OBJECTION TO PROPOSED BYLONG COAL MINE ON THE FOLLOWING GROUNDS

Figure 10-3 Vertical hydraulic conductivity of fracture zone

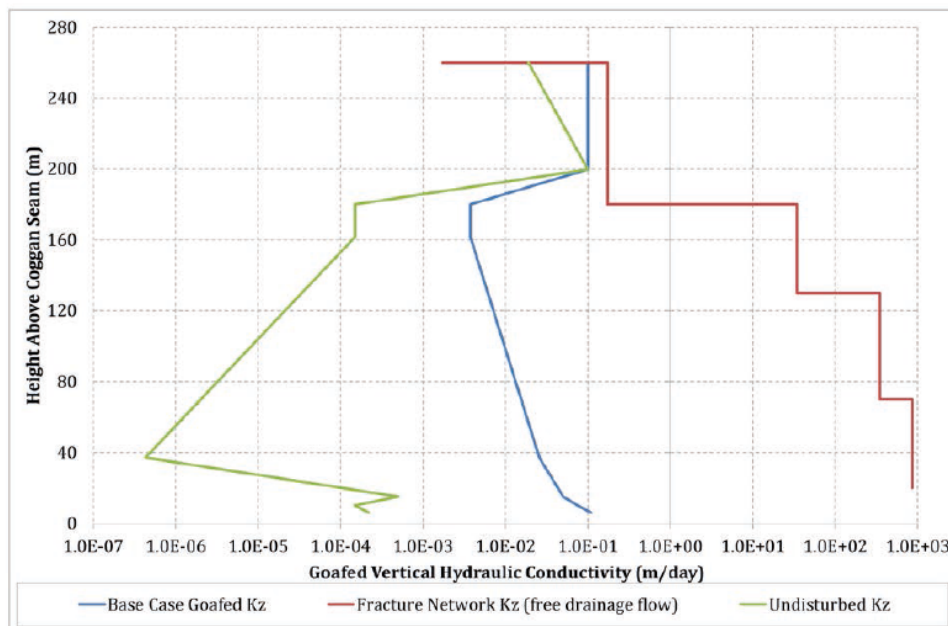
The maximum modelled goafed K_z value of 0.1" (blue line) is an extreme underestimation below 40 that the Tammetta paper quotes for the cracked zone and still compares badly to the "10 or less " recommended for the so-called disturbed zone. The modelled K_z value of 0.01 at say 100 m above the longwall gallery is one four thousandth of the Tammetta recommended value of 40 for the cracked zone. The resulting claim that there will be only a 2 m fall in the water table is therefore dubious.

The adoption of the modelled K values is vaguely justified as “adjusted to a value between the free draining vertical hydraulic conductivity value provided by SCT (2015) and the undisturbed host rock values” but with no definition of how exactly in between the chosen values are.

The diagram suggests a midway point but the chart is misleading because it is based on a logarithmic scale and insight comes from the peer review which refers to taking the geometric mean. Any reduction of K values below that recommended by Mr Tammetta must be viewed with suspicion, but to arbitrarily take a geometric mean over a range of up to a billion-fold is absurd.
